# UNITED STATES PATENT AND TRADEMARK OFFICE

APPLICATION NO.	FILING DATE	FIRST NAMED INVENTOR	ATTORNEY DOCKET NO.	CONFIRMATION NO.
10/732,943	12/11/2003	Janine L. Cox	COX 02.01	7265

<b>Office Action Summary</b>	Application No. 10/732,943	Applicant(s) COX ET AL.	
	Examiner Trinh T Nguyen	Art Unit 3644

## **DETAILED ACTION**

3,838,664

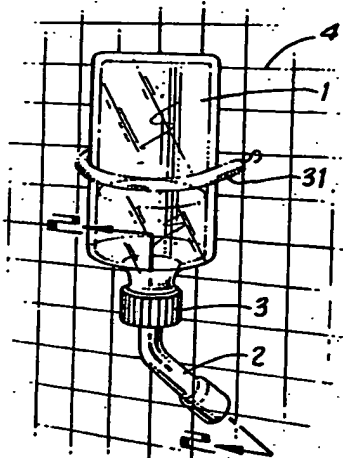
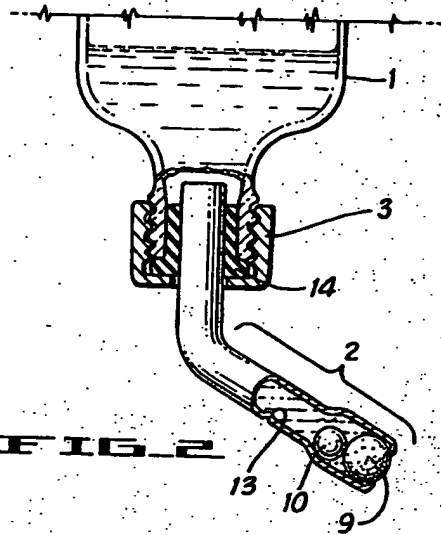
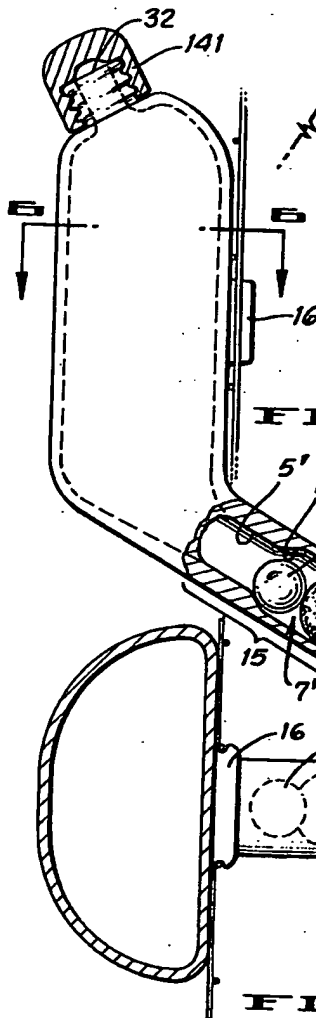
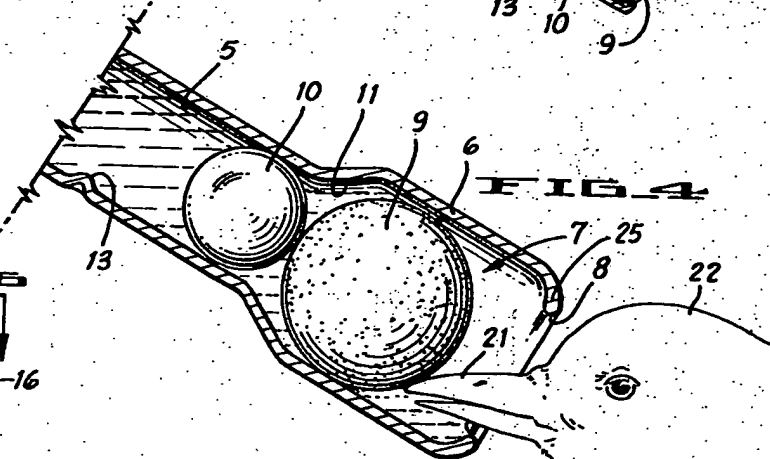
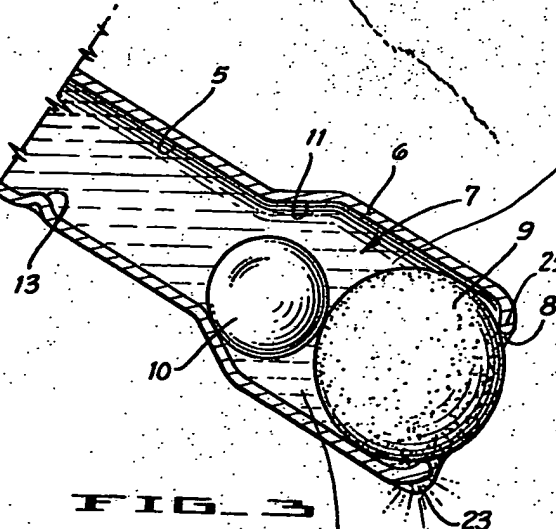
Atchley discloses a bird feeder, comprising: a first reservoir (1) comprising an output port; liquid hummingbird food disposed in said first reservoir; and a fluid conduit (2) comprising a first end, and a second end, wherein said first end can be releaseably attached to said output port.

For claim 3, Atchley further discloses a flow restrictor (9, 10) disposed within said fluid conduit adjacent said second end.

For claim 4, Atchley lacks the teaching of a flow restrictor comprises a cellular material having a plurality of individual fluid flow channel disposed therethrough. However, it is noted that Atchley discloses the use of members (9, 10) as flow restrictor wherein the flow restrictor having a plurality of individual fluid flow channel (see attached Figure 3 of Atchley at the end of this Office Action), which is considered as a flow restrictor functional equivalent to the flow restrictor as claimed, for restricting the flow of liquid in the conduit. Therefore, it would have been obvious to one of ordinary skill in the art to use either Atchley's flow restrictor or Applicant's flow restrictor, since to do so would merely replace one old and well known flow restrictor means with another art equivalent old and well known flow restrictor means.
